RE: PADEP Letter dated 12/21/16  
Sunrise Lakes- Section 9 Community Wastewater Treatment System  
Dingman Township Pike Co.  
VW#16-19

On behalf of Appletree Resource Group, Inc. the management consultant for Sunrise Lake section 9 residents, VW Consultants, LLC (VW) would like to respond to the PADEP letter of 12/21/16. Our response includes information provided by Appletree Resource Group, Inc. (Appletree); their service provider M&S Septic Services (M&S) and the inspection company of Pike County Septic & Environmental Management, LLC (PCSEM). We shall respond in the order listed in the PADEP letter:

**SITE PLAN**

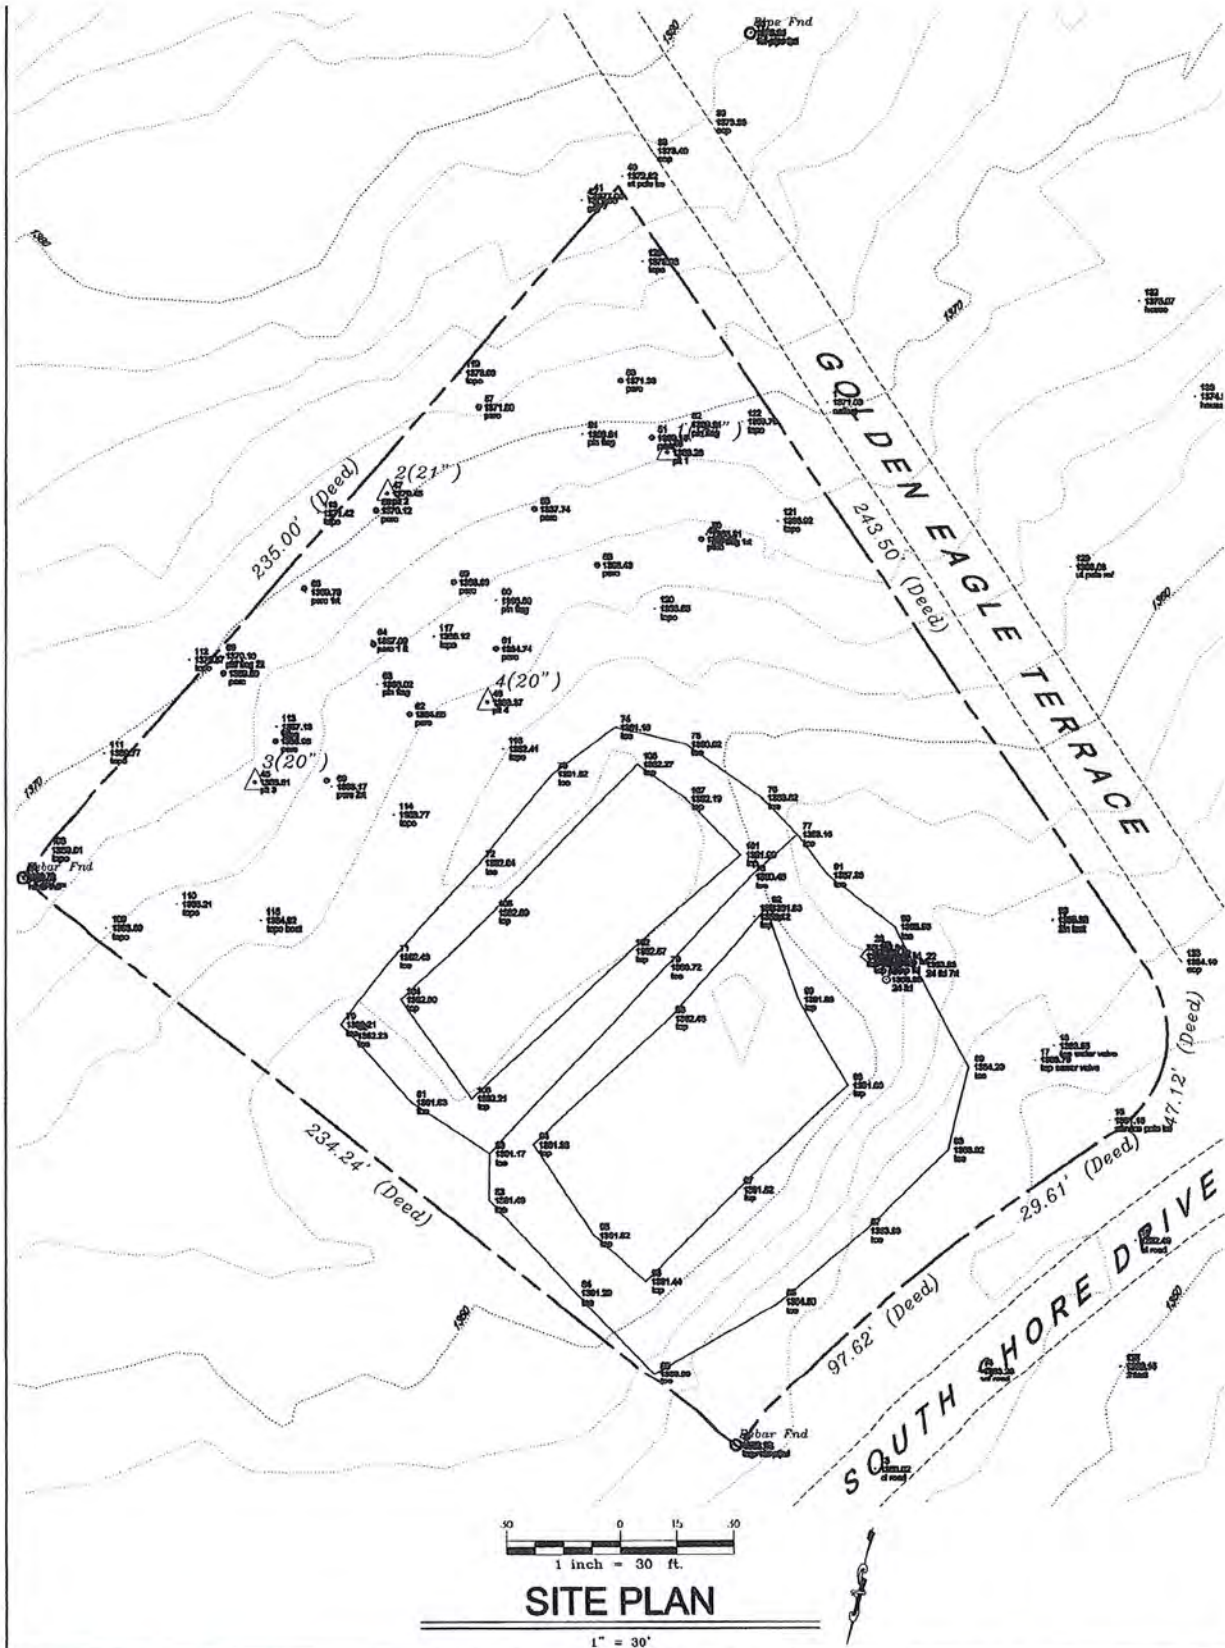
2. Enclosed is a sketch provided to us from Appletree. A detailed plan has not yet been obtained from the Homeowner's Association. We have enclosed a location plan prepared by VW which shows the recent site testing conducted by VW. Enclosed is a copy of the preliminary design plan for section 9 site A.
